Technical Review Committee Agenda

**CITY OF DELAND
THURSDAY MAY 16, 2024 AT 1:30 P.M.
CITY OF DELAND TRC MEETING ROOM
DELAND, FLORIDA**

City of DeLand
PSB24-090
PRELIMINARY PLAT
FOR TAYLOR RIDGE

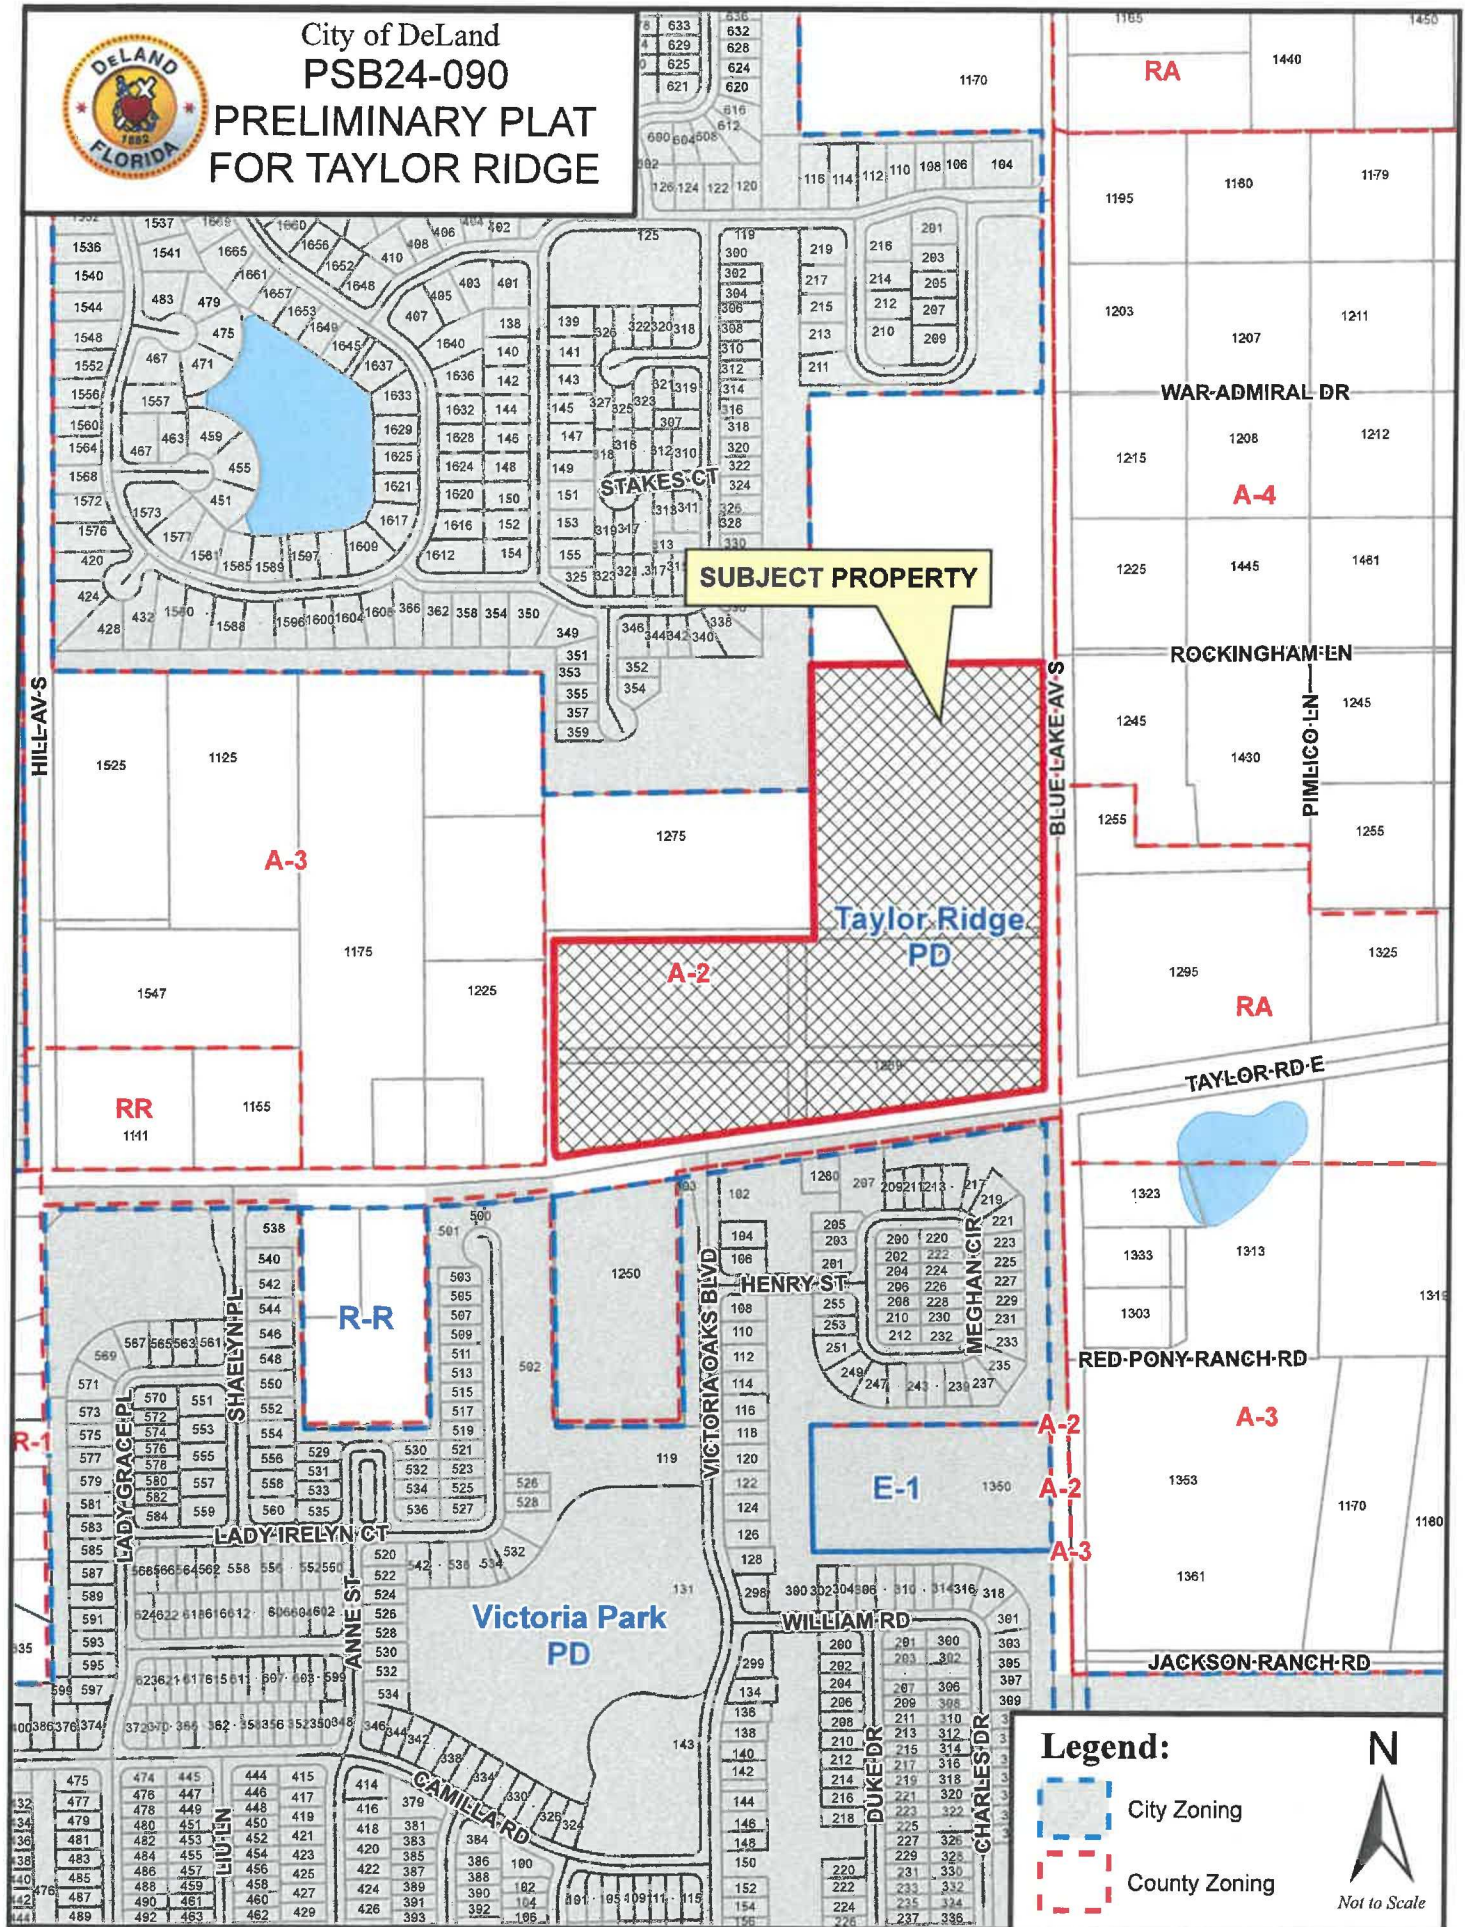
Discipline	Status	Details	Attached To	Created By	Last Updated By	Modifications Required
Engineering	Draft	Lift Station Elevation It appears that the area around the proposed lift station will retain stormwater. Ensure that the lift station is elevated to avoid inundation during major storm events.	C-4.1	Steven Danskine	Steven Danskine	Yes
Engineering	Draft	Unidentified Symbolology It is unclear what information the line north of lots 60 - 65 is intended to convey.	C-4.0	Steven Danskine	Steven Danskine	Yes
Engineering	Draft	Stormwater Report and Permit 1. Provide a SJRWMD Permit prior to scheduling a Pre-Construction Conference. 2. Provide a stormwater model for the project that includes the 100-yr/24-hr and 25-yr/96-hr storm events. 3. The tailwater conditions for each pond should be set at the 10-yr/24-hr storm elevation. 4. Provide HGL calculations to avoid roadway flooding. 5. The weir in storm structure A-6 is above curb inlets A-8 and A-8A, as well as Inlet A-9 top elevations. This may cause water to stage in the roadway.	C-4.0	Steven Danskine	Steven Danskine	Yes

Engineering	Draft	Retaining Walls and Handrails Provide retaining wall and handrail details as appropriate.	C-4.0	Steven Danskine	Steven Danskine	Yes
Engineering	Draft	Televise Storm Piping Provide a note that prior to acceptance of storm sewer infrastructure, all storm pipes are to be televised and the recordings along with reports shall be provided in electronic format to the City for review and comment.	GN-1.0	Steven Danskine	Steven Danskine	Yes
Engineering	Draft	Volusia County Access Permits Blue Lake Ave and Taylor Rd are Volusia County Rights of Way. Provide Access Permits prior to a Pre-Construction Meeting.	C-7.0	Steven Danskine	Steven Danskine	Yes
Engineering	Draft	Site Key Sheet Reference Please indicate on the Site Key where the Plan and Profiles shown are represented for this and subsequent sheets.	C-6.0	Steven Danskine	Steven Danskine	Yes
Engineering	Draft	Mail Kiosk Will there be a central mail kiosk? If so, provide a handicapped parking spot in proximity	C-3.0	Steven Danskine	Steven Danskine	Yes

Discipline	Status	Details	Attached To	Created By	Last Updated By	Modifications Required
to the kiosk.						
Common Area Sidewalks						
Engineering	Draft	Denote common area sidewalks that will be constructed in conjunction with the roadways.	C-3.0	Steven Danskine	Steven Danskine	Yes
Grading to Match Existing						
Engineering	Draft	Provide grading information to indicate how the transitions are to be made back to existing grade. Grading should not adversely impact tree protection areas.	C-4.0	Steven Danskine	Steven Danskine	Yes
Grading and FFE's						
Engineering	Draft	1. Finished Floor Elevations shall be at least 1-foot above the adjacent crown of road, e.g. Lot 65. Please review for others. 2. Review lot grading to ensure runoff flows as intended, e.g. Lots 31 & 50 side yard drainage. Please review for others.	C-4.0	Steven Danskine	Steven Danskine	Yes
Fire Hydrants						
Fire	Draft	Additional fire hydrants will be required. Distance between hydrants exceeds 600 ft.	C-5.0	Jamie Lunsford	Jamie Lunsford	Yes

Fire Hydrants						
Fire	Draft	Additional fire hydrants will be required. Distance between hydrants exceeds 600 ft.	C-4.1	Jamie Lunsford	Jamie Lunsford	Yes
Tree Locations						
Forestry	Draft	You appear to be planting trees in areas that will block the stop sign and create line of sight issues at the intersection. Please review the locations of these trees.	L402	Kit Dennis	Kit Dennis	Yes

2.15 Balled/Burlapped/Wire Balled						
Forestry	Draft	A note should be added here stating that wire baskets should be removed from the top 1/3 of the rootball.	L432	Kit Dennis	Kit Dennis	Yes
Tree Barricade Detail						
Forestry	Draft	Update the Tree Barricade Detail with the latest version. It can be found on our website. You will also need to add out Historic Tree Barricade Detail to the plan.	L431	Kit Dennis	Kit Dennis	Yes
Tree Planting Detail						
Forestry	Draft	Your scope of work specifies "ArborBrace" or "ArborGuy" tree staking kits on sheet L432 (2.09 A). This is not what is shown in the detail.	L431	Kit Dennis	Kit Dennis	Yes
Historic Tree Mitigation						
Forestry	Draft	Your plant schedule provides 2 trees that meet the minimum requirements for historic removal replacement trees. These trees provide 14" DBH replacement of the required 86" DBH. How do you plan to mitigate the remaining 72" for the historic removals.	L430	Kit Dennis	Kit Dennis	Yes

Root Barrier Notes						
Forestry	Draft	These state that they are to be installed if a tree is within 5' of an underground utility.	L430	Kit Dennis	Kit Dennis	Yes

What would be the purpose for doing that? The detail on L431 shows them being installed where trees are planted near curbs and sidewalks, which makes more sense. Please correct the notes or the detail.

Forestry	Draft	QV & QVB Why are these labeled differently? The species and specifications are identical.	L430	Kit Dennis	Kit Dennis	Yes
Plant Schedule						
3" caliper is our minimum size replacement tree. If you want to receive replacement credit for the proposed trees the specifications will need to be updated. Changes needed are shown below.						
Forestry	Draft	AR - 3" cal, 8' ht, 4' spd, 45 gallon	L430	Kit Dennis	Kit Dennis	Yes
		CC - 3" cal, 8' ht, 3.5' spd, 45 gallon				
		LS - 3" cal, 8' ht, 4' spd, 45 gallon				
		MGB - 3" cal, 8' ht, 2' spd, 45 gallon				
		PE - 3" cal, 2' spd, 45 gallon				
		QV & QVB - 3" cal, 8' ht, 4' spd, 45 gallon				
		TD - 3" cal, 2' spd, 45 gallon				
Forestry	Draft	UAS - 9' ht, 5' spd, 65 gallon	L205	Mariellen Calabro	Mariellen Calabro	Yes
		LIN - 3" cal, 8' ht, 3.5' spd, 45 gallon				
		PAN - 3" cal, 8' ht, 3.5' spd, 45 gallon				
		Tree Protection Area Change Tree Preservation Area to Tree Protection Area to remain consistent with Code.

Tree Protection Area Change Tree Preservation Area to Tree Protection Area to be consistent with Code language.				
Forestry	Draft	Tree Preservation Area Change Tree Preservation Area to Tree Protection Area to remain consistent with Code language.	L201	Mariellen Calabro	Mariellen Calabro	Yes
Forestry	Draft	Note 2. In the fourth line of note 2, change 2015 to 2022. (2022 is the latest edition)	L420	Kit Dennis	Kit Dennis	Yes
Lot Tree List (Medium Trees)						
Please make the following changes to the specifications to meet grade 1 standards.						
Forestry	Draft	Eastern Redbud - 9' HT, 100 Gallon	L420	Kit Dennis	Kit Dennis	Yes
		Japanese Blueberry - 3' sp, 100 Gallon				
		East Palatka Holly - 3' sp, 100 Gallon				
		Dahoon Holly - 3' sp, 100 Gallon				
		American Holly - 6' sp, 100 Gallon				
		Crape Myrtle - 9' HT, 100 Gallon

Discipline	Status	Details	Attached To	Created By	Last Updated By	Modifications Required
Lot Tree List (Large Trees)						
Forestry	Draft	Acer saccharum is Sugar Maple and not found in our hardness zone, nor is it on our List of Approved Replacement Trees. The list at the bottom of the page shows it as Acer barbatum which is in our hardness zone and would be accepted as a replacement species. Please correct it on the lot tree list. The specifications for the "large trees" you list should all be changed to show a 72" spread and 100 gallon container size.	L420	Kit Dennis	Kit Dennis	Yes
Decimal Places						
Forestry	Draft	Please round calculations to nearest whole number. For example, 863.3333 in the Section 7 table, should be 863" per acre. Any number that ends in 0.5 or more, should be rounded to the next whole number. So, Section 8 table should be 1123" per acre. There are more examples throughout the document.	L110	Mariellen Calabro	Mariellen Calabro	Yes

Proposed Lot Trees						
Forestry	Draft	The requirement is 1 tree per 2500 sqft. Lots shown as less than 6262 sqft would require 2 trees. Lots shown 6262 sqft to 8,400 sqft require 3 trees. Lot #55 would require 4 trees. Please update the chart to show the correct number of trees for each lot.	L420	Kit Dennis	Kit Dennis	Yes
Palm Tree Summary						
Forestry	Draft	90 palms will meet the allowed 25% of replacement palms being counted towards mitigation requirements. The 90 palms will count as 360" DBH replacement. For the individual lots there is a maximum of 41 Palms. Only one palm will count per lot, up to 41 lots. Please revise the Palm Tree Summary Table.	L110	Kit Dennis	Kit Dennis	Yes
Tree Barricade Detail						
Forestry	Draft	Update with the most recent detail. It can be found on our website. You will also need to add our Historic Tree Barricade Detail to the plan.	L110	Kit Dennis	Kit Dennis	Yes

Survey Sections						
Forestry	Draft	What are the coverage types for the different sections? Please label the sections with coverage type and show the locations of the different types on the plan. Per the PD sample areas cannot be less than one acre.	L110	Kit Dennis	Kit Dennis	Yes
Small Tree Survey						
Forestry	Draft	Revise the text to show 2"-5.4" Live Oak trees to be surveyed for NVRA credit. Trees 5.5" would be 6" trees. Mitigation calculations cannot be finalized until the NVRA credit has been determined.	L110	Kit Dennis	Kit Dennis	Yes
Statistical Summary						
Forestry	Draft	How did you calculate the total shown? The way I'm looking at it, your per acre totals add up to 9,874 with an average per acre of 1234, for a total estimate of 21,205". Please explain how you have calculated this.	L110	Kit Dennis	Mariellen Calabro	Yes

Discipline	Status	Details	Attached To	Created By	Last Updated By	Modifications Required
Forestry	Draft	Tree Coverage Table Your minimum coverage calculations are correct for a 17.18 AC site. How did you calculate the overage inches? The chart shows 2,237" proposed and 316" retained for a total of 2,553". A minimum coverage requirement of 1,794" means you would have an overage of 759", the chart shows 443".	L110	Kit Dennis	Kit Dennis	Yes
Forestry	Draft	Net Developable Area How did you calculate this acreage? 26.01 AC site total minus 1.14 AC powerline easement (Per PD) is 24.87 AC of developable area.	L110	Kit Dennis	Kit Dennis	Yes
Forestry	Draft	Tree Worksheets Please submit completed tree worksheets. The worksheets can be found on our website.	L110	Kit Dennis	Kit Dennis	Yes
Forestry	Draft	Non Consistent Data Tree data needs to be consistent throughout the plans, and match what is provided in your tree survey and arborist report. Example: Tree CO18 is labeled as a 20" tree here but is listed as an 18" tree in the spreadsheet you provided.	L100	Kit Dennis	Kit Dennis	Yes

Forestry	Draft	Specimen Trees There is not a specimen designation for Laurel Oaks. You are showing them as specimen removals and retained. Please make the corrections on the plan in your tree calculations as needed.	L100	Kit Dennis	Kit Dennis	Yes
Forestry	Draft	48" Historic Oak Your arborist report lists this tree as "Poor - 80% dead with advanced trunk decay." Change the condition rating shown for this tree to be consistent with the report you provided. I would recommend avoiding a walking trail near this tree, based on the information provided.	L100	Kit Dennis	Kit Dennis	Yes
Forestry	Draft	Lots 20 & 21 You are proposing to preserve a historic tree near lots 20 & 21. No filling or grading is permitted within 1 1/2 times the dripline of this tree.	C-4.1	Kit Dennis	Kit Dennis	Yes
Forestry	Draft	Tree Protection Areas (Label) Please label the Tree Protection Areas.	C-2.0	Kit Dennis	Kit Dennis	Yes

Forestry	Draft	Note 1 It doesn't appear that you are proposing any Tree Protection Areas with a width of less than 30'. If you are, please show the widths on the plan. If you are not, please remove the note from the plan.	TR-1.0	Kit Dennis	Kit Dennis	Yes
Forestry	Draft	Preserved Historic Tree You are showing that you plan to preserve a 48" DBH historic Live Oak. The arborist report states that this tree is "80% dead with advanced trunk decay." I would recommend that you avoid a walking trail next to this tree as shown on your plan.	TR-1.0	Kit Dennis	Kit Dennis	Yes

Discipline	Status	Details	Attached To	Created By	Last Updated By	Modifications Required
Forestry	Draft	Information Consistency The information provided should be consistent throughout the plan. The tree identifications on the sheets do not match the spreadsheet provided. For example, tree CO25 in the plan sheets is tree HO25 in the spreadsheet. Please make the needed corrections so that the information is consistent.	TR-1.0	Kit Dennis	Kit Dennis	Yes
Forestry	Draft	Legend Add the green tree symbols to the legend and state what they are identifying.	TR-1.0	Kit Dennis	Kit Dennis	Yes
Forestry	Draft	Historic Trees The tree survey identified three historic trees. This sheet identifies one. Identify the locations of the other two historic trees.	TR-1.0	Kit Dennis	Kit Dennis	Yes
Forestry	Draft	Historic Tree Protection Detail Your plan preserves one historic tree. Add the City's Historic Tree Barricade Detail to this page. It can be found on our website.	TR-1.0	Kit Dennis	Kit Dennis	Yes

Forestry	Draft	Tree Barricade Detail Update with the most current (1/11/24) version of the detail. It is available on our website.	TR-1.0	Kit Dennis	Kit Dennis	Yes
Planning	Draft	Fencing Will there be any fencing? If yes, please show the location(s) on the plan and notate the height, length, material.	C-2.0	Kendall Story	Kendall Story	Yes
Planning	Draft	Parallel parking - not wide enough On street parallel parking must be a minimum of 8.5' wide. The plans show only 6'. Please adjust the sizing.	C-3.0	Kendall Story	Kendall Story	Yes
Planning	Draft	Parking counts Please note the number of parking spaces in each section of on-street parking. Per the PD, at least 31 spaces are required. I only counted 30 spaces. Please revise.	C-2.0	Kendall Story	Kendall Story	Yes
Planning	Draft	Buffer south of lots 31-35 The PD requires a 10' landscape buffer south of lots 31-35. This is shown properly on the landscape plan, however, there appears to be a wall or trail shown in the buffer location on this sheet. Please confirm there is enough space for the buffer and clarify what the object is (see mark ups).	C-2.0	Kendall Story	Kendall Story	Yes

Planning	Draft	Amenities Please provide dimensional details on each of the provided amenities, such as the sidewalks, pavilion area, play field, dog park etc.	C-2.0	Kendall Story	Kendall Story	Yes
Planning	Draft	Legend for Trails Please provide a legend for all trails, providing the type/material and width.	C-2.0	Kendall Story	Kendall Story	Yes

Discipline	Status	Details	Attached To	Created By	Last Updated By	Modifications Required
Planning	Draft	Draft Final Plat A draft final plat is required as part of your submittal. Please provide the draft with your next submittal.	C-2.0	Kendall Story	Kendall Story	Yes
Planning	Draft	Traffic memo Please provide a traffic impact statement/memo. If less than 1,000 average daily trips, a full traffic impact analysis is not required.	C-2.0	Kendall Story	Kendall Story	Yes
Planning	Draft	Environmental Report Please provide an environmental study in accordance with section 33-60.02	C-2.0	Kendall Story	Kendall Story	Yes
Planning	Draft	Setback to structure Per the PD, the minimum front yard setback to the structure is 15', not 25'. (The 25' setback is to the garage). Please update the site data to reflect the PD. See below. Front yard setback (to garage face/door): 25' Front yard setback (to the structure): 15'	C-2.0	Kendall Story	Kendall Story	Yes

Planning	Draft	Future Land Use The Future Land Use is Transitional Residential Development (TRD), not Low Density Residential. Please update the information.	C-2.0	Kendall Story	Kendall Story	Yes
Planning	Draft	Delineate Buffers Please delineate all landscape buffers, showing the width and noting the Buffer Type (A/B/C/D) in accordance with the Taylor Ridge PD. *Do this for all pages applicable in the landscape plan set.	L402	Kendall Story	Kendall Story	Yes
Planning	Draft	**Beresford Extension Note (remove) Please remove the note that states: " **South buffer to include required reservation for the existing portions of the Beresford Ave. Extension", as it does not apply to this project.	L430	Kendall Story	Kendall Story	Yes
Planning	Draft	Linear Feet of Each Buffer The LF of each buffer should coincide with the property boundary lines. For example: the table says the linear feet of the south buffer is 367'. However, the southern property line is a total of 1250'. Your calculations should be based upon 1250 linear feet. Also, the west buffer needs to be included in the table.	L430	Kendall Story	Kendall Story	Yes

Utilities	Draft	Utility Note 1. D Change Orange county to City of DeLand.	GN-1.0	Jim Ailes	Jim Ailes	Yes
Utilities	Draft	Lift Station No force main shown leaving lift station and connecting to any system. L/S site also	C-6.2	Jim Ailes	Jim Ailes	Yes

Discipline	Status	Details	Attached To	Created By	Last Updated By	Modifications Required
needs water service shown.						
Utilities	Draft	Tie in connection Show how and where the utilities will be connected.	C-6.3	Jim Ailes	Jim Ailes	Yes
Utilities	Draft	Utility Connections Show tie in to mains.	C-6.0	Jim Ailes	Jim Ailes	Yes
Utilities	Draft	Reuse Reuse line needs to be connected and looped.	C-5.1	Jim Ailes	Jim Ailes	Yes
Utilities	Draft	USA This project will require a utility service agreement to be signed prior to construction.	C-1.0	Jim Ailes	Jim Ailes	Yes
Utilities	Draft	Water Tie In Would like to see the end of the line connect to existing water main so the potable system is looped and is fed from two directions.	C-5.1	Scott Zender	Scott Zender	Yes
Utilities	Draft	Force Main Show force main and were its connecting to existing sewer	C-5.1	Scott Zender	Scott Zender	Yes
Utilities	Draft	Tie In No connections shown for water, sewer force main, and reclaim being connected to city main lines.	C-5.0	Scott Zender	Jim Ailes	Yes
